**From:**  
**Sent:** 16 June 2022 12:18  
**To:**  
**Subject:** RE: PPA0006626 Barry Waterfront Campus (BWC),Hood Road, Barry, Vale of Glamorgan, CF62 5QU

### BWC storm discharge rate

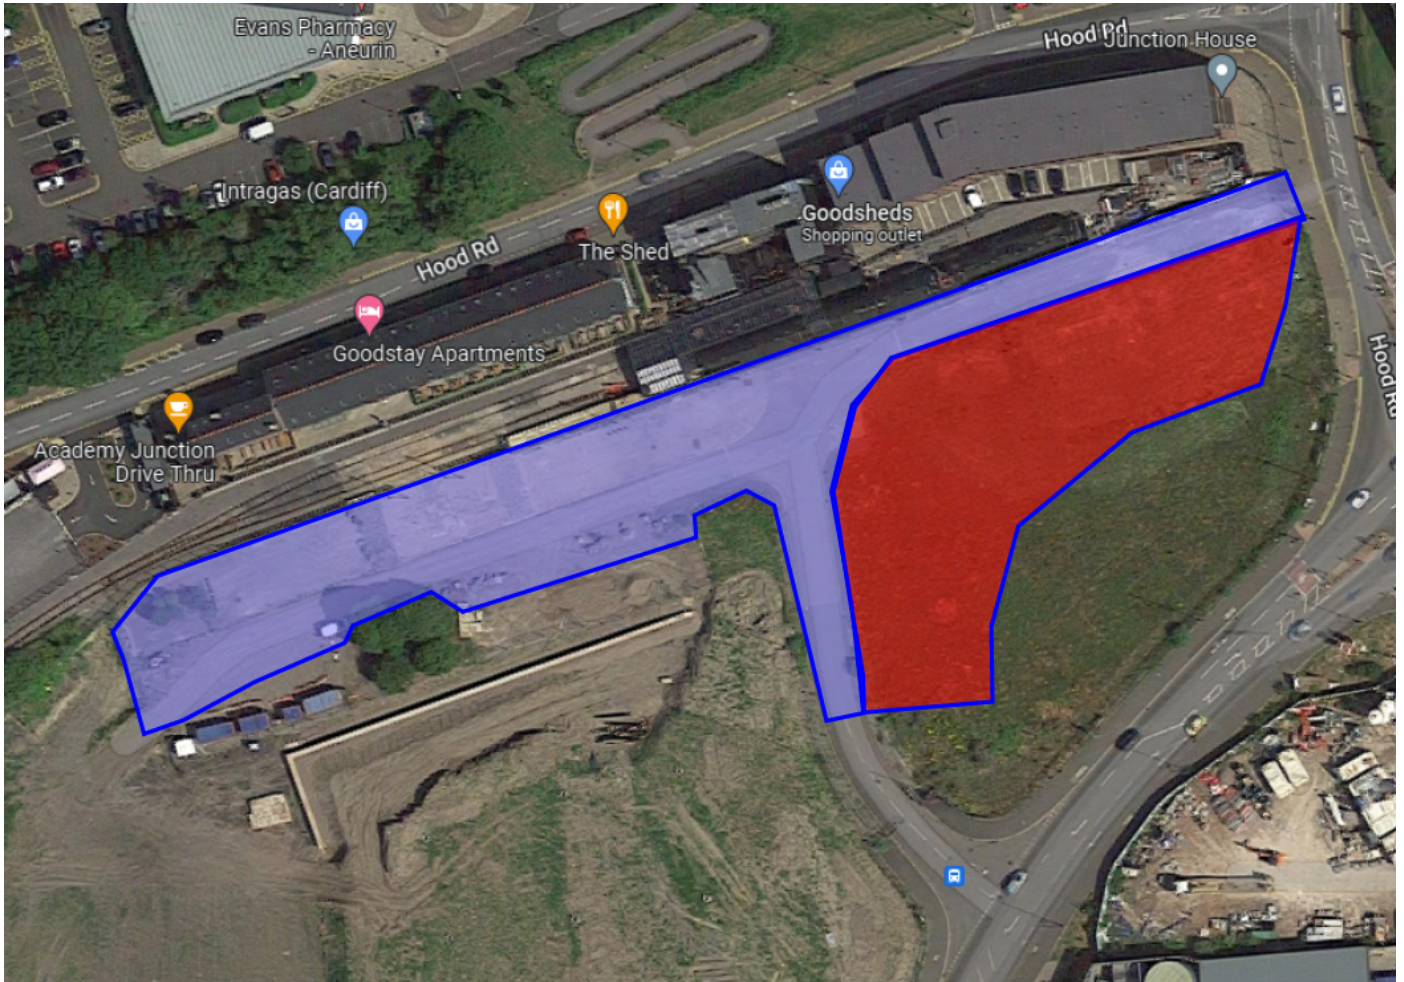
The reason we proposed to simply match the existing flow rates below is although the site outfalls into the 600mm diameter DCWW network in Ffrod y Mileniwm, the ultimate outfall is the Barry Dock not even 300m away:

In discussion with ABP, they have confirmed that the only flow entering the dock is from direct rainfall falling on the water surface or from storm sewer outfalls from the surrounding roads/developments. The water level is controlled by the dock gates and the top of the gates are set lower than the coping stone level around the dock perimeter. The water level in the dock is therefore controlled, constant and consistent.

Considering the large surface area of the dock water, the flood risk of the ultimate receptor will likely not change significantly if the flow rate entering the dock from our site is reduced.
